TECHNICAL INFORMATION

63707

- Subject** ▶ Change of Hexagonal Nut, Flat Washer and Spring Washer
- For Models** ▶ 4107B, 4107R, 4107RH, 4108R, 5100BR, 5103N, 5103NA, 5201N, 5201NA, 5401N, 5401NA, 5402, 5402A, 5700, 5900BR
- Country** ▶ All countries
- Description** ▶ Hex. Nut, Flat Washer and Spring Washer at the hinge portion shown below have been replaced by Hex. Lock Nut M6-10 for quick repairing.

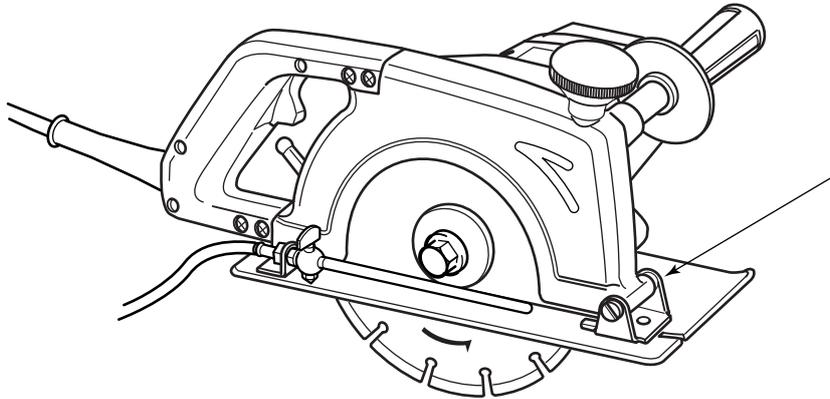
Hex. Nut, Flat Washer and Spring Washer at this hinge portion replaced by Hex. Lock Nut M6-10

Item No.	Current part	Q'ty	I/C	New part	Q'ty	Note
5700: 066 5900BR: 047	Hex. Nut M6 931302-2	1	←	Hex. Lock Nut M6-10 252014-7	1	Interchangeable as a set
5700: 064 5900BR: 049	Flat Washer 6 941151-9	1	No			
5700: 065 5900BR: 048	Spring Washer 6 942151-2	1	No

Item No.	Current part	Q'ty	I/C	New part	Q'ty	Note
See A below	Hex. Nut M8 931401-0	1	←	Hex. Lock Nut M8-13 252105-4	1	Interchangeable as a set
See B below	Flat Washer 8 941201-0	1	No			
See C below	Spring Washer 8 942201-3	1	No
